APPLICATION FOR PERMIT
TYPE I MUNICIPAL SOLID WASTE FACILITY
MSW PERMIT NO. 2374
PESCADITO ENVIRONMENTAL
RESOURCE CENTER
RANCHO VIEJO WASTE MANAGEMENT, LLC
SOLID WASTE DISPOSAL FACILITY
LAREDO, WEBB COUNTY, TEXAS

**Reference: Pescadito Environmental Resource Center – Webb County
Municipal Solid Waste (MSW) – Proposed Permit No. 2374
Response to Second Notice of Deficiency (NOD)
Tracking No. 14669041; CN603835489/RN106119639**

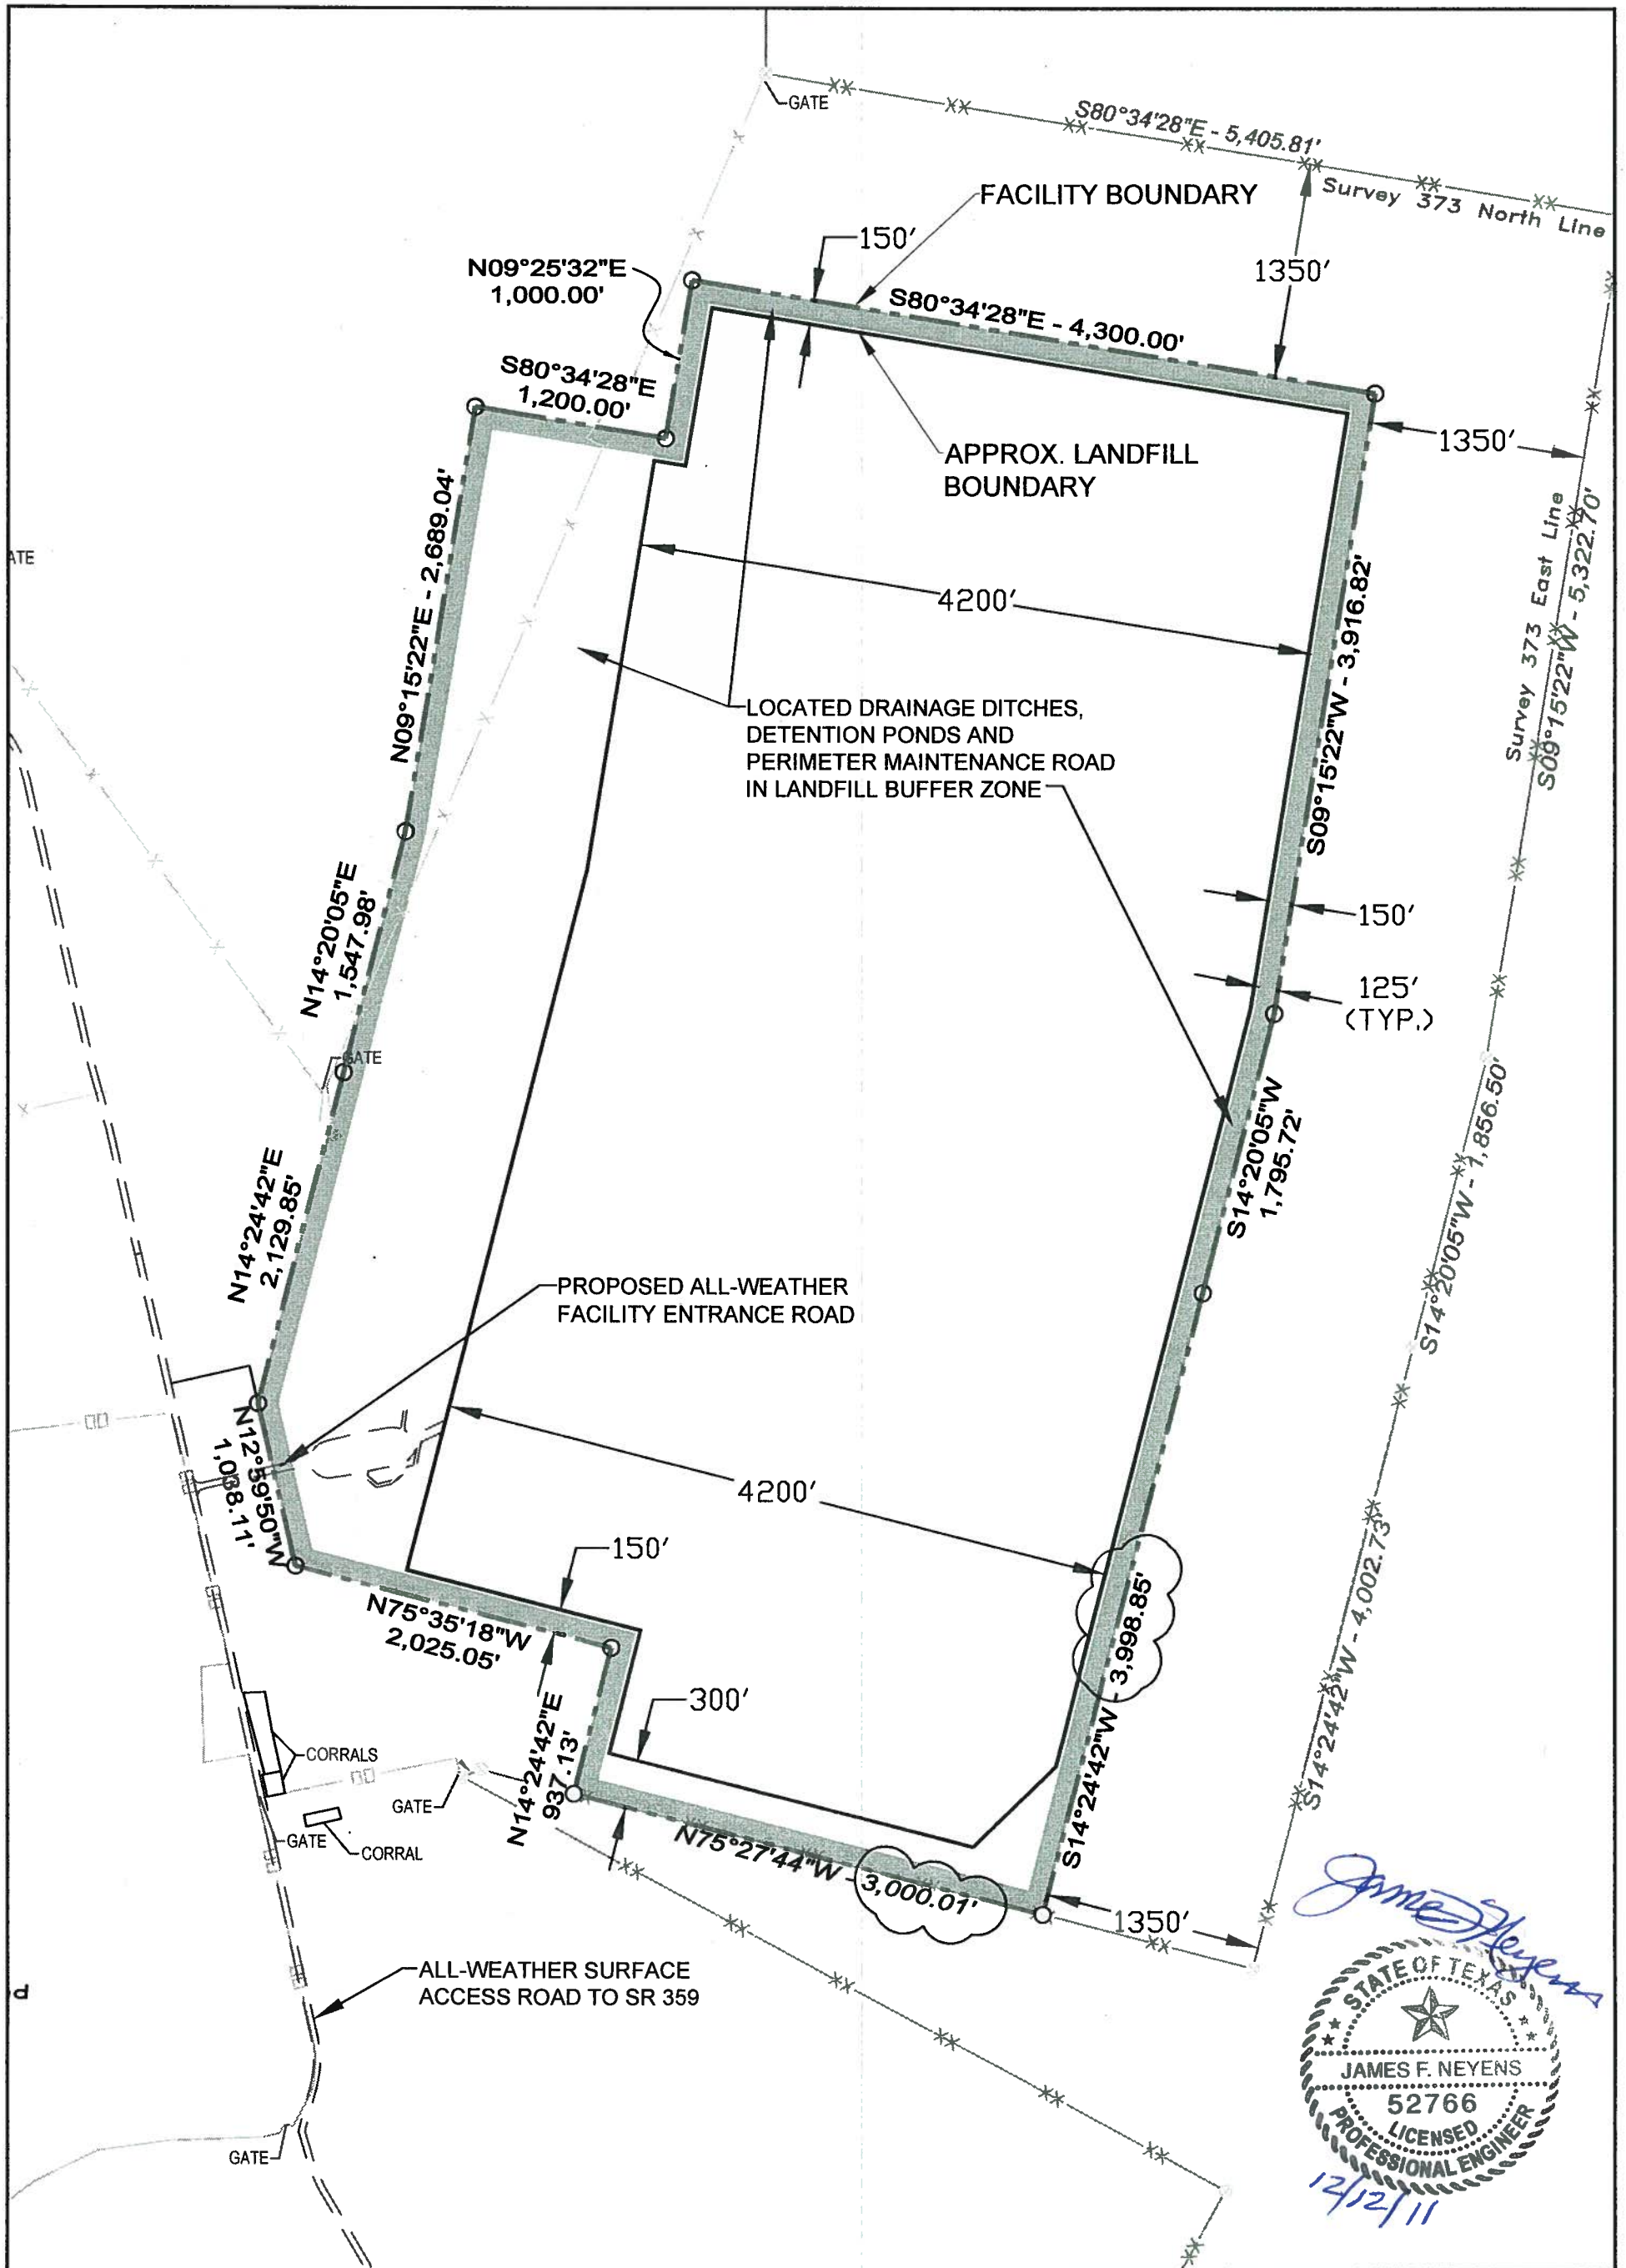
17. *(Item 33 from NOD #1) The last sentence in Part II Section 4.0 identifies buffers as being more than one-quarter mile on three sides and 300 feet on the fourth side. Please revise this language since the identified distances do not consistently appear to be within the proposed permit boundary. Please provide a drawing to show the proposed buffer zone or otherwise appropriately identify the buffer zone. Furthermore, please ensure that the buffer zone is consistent with the requirements to be within and adjacent to the proposed permit boundary and, no less than 125 feet wide. Please be aware that no waste management activities may be authorized within an area designated as a buffer zone. (30 TAC §330.543(b)(1)(B))*

We have clarified the last sentence in Part II, Section 4.0, page 17 regarding buffers. We have added the location of the prescribed 125-foot-wide buffer zone on Part II, Figures 3 and 4.

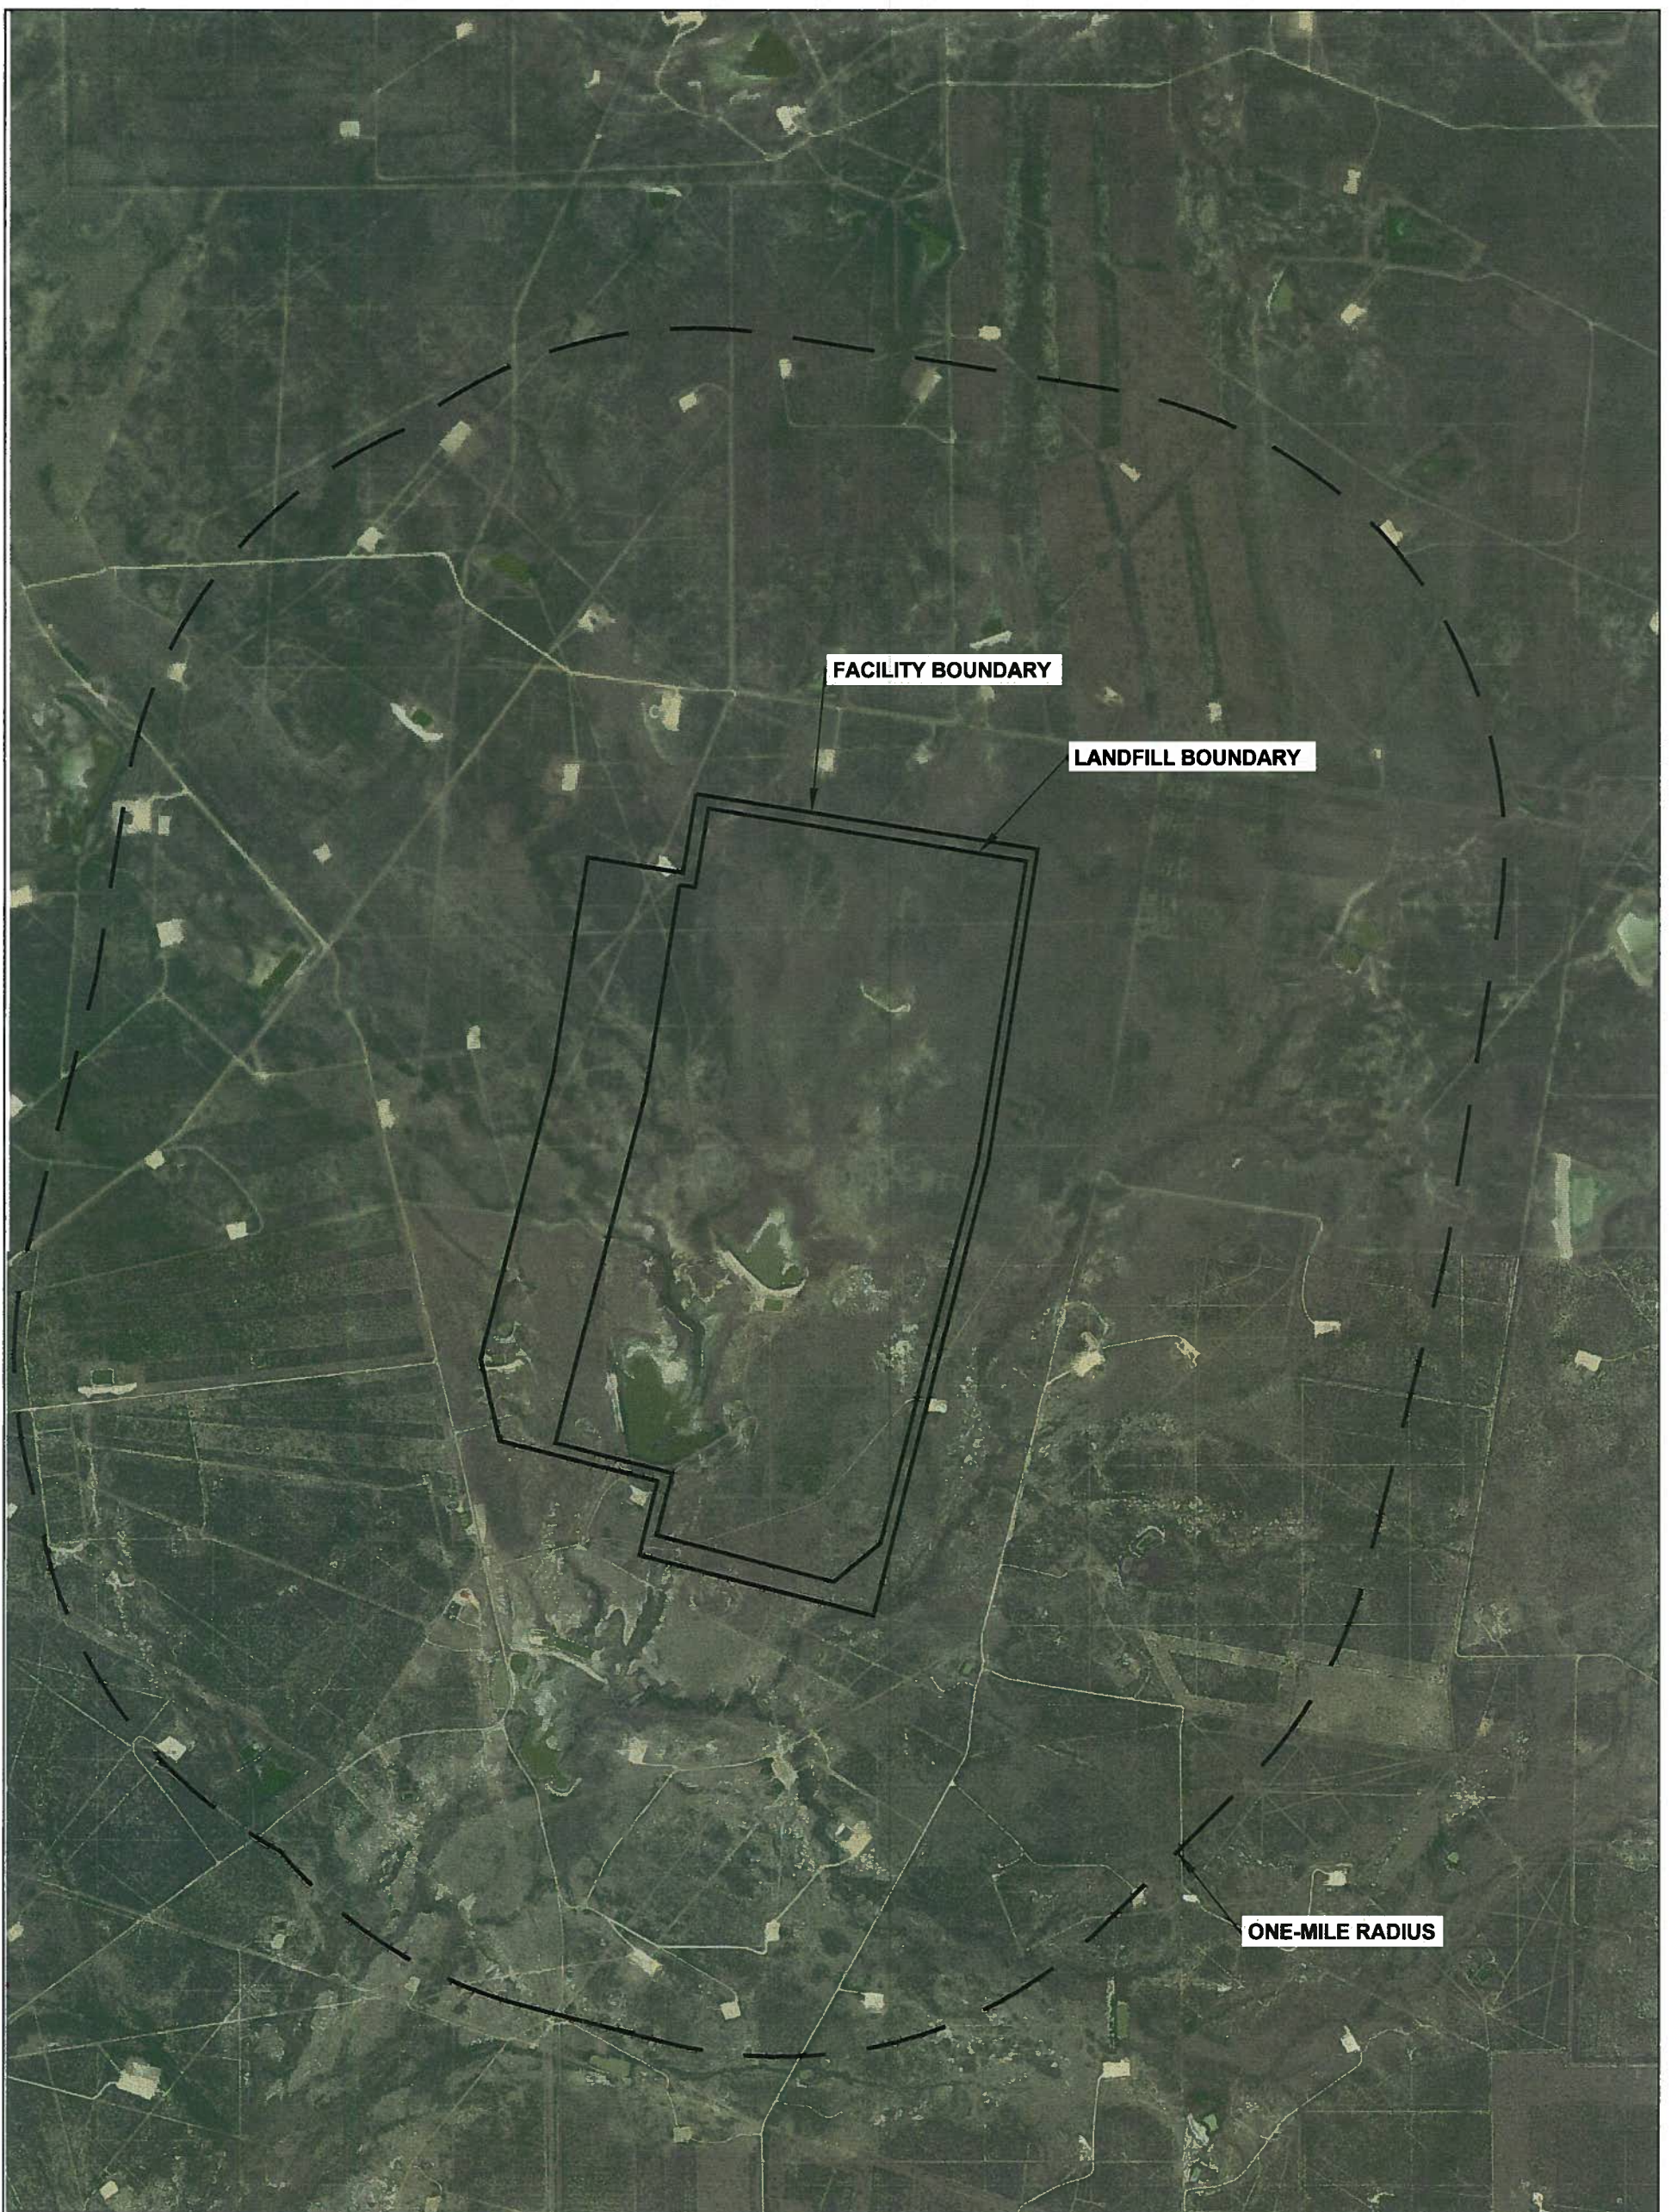
19. *(Item 44 from NOD #1) Language in Part II Section 6.0 pertaining to the aerial photograph states that no fill area exists and can therefore not be shown. However, the intent of the requirement is that proposed fill areas be shown in addition to any that may exist. Please revise Section 6.0 and Figure 7 to include the proposed fill area. (30 TAC §330.61(f)(1))*

Part II, Section 6.0, page 19 and Figure 7 have been revised regarding the proposed fill area.
